v22 Revisions

fabrick.it x-LED Brick
<http://fabrick.it/bricks/x-led-brick/>

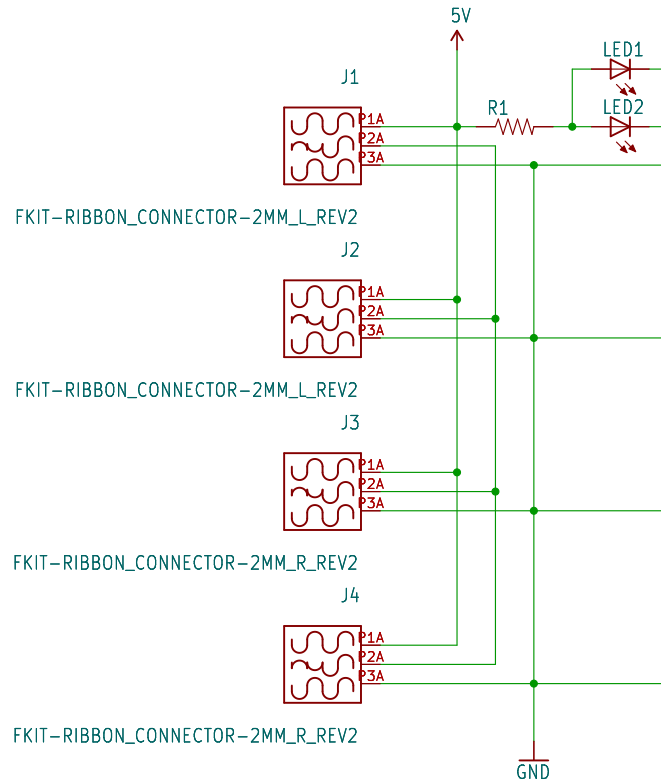
Moved resistor to accomodate 5mm LED
Moved tPlace +/- LED indicators
removed bPlace +/- indicators (interfere with logo)
Added 2 sewing holes
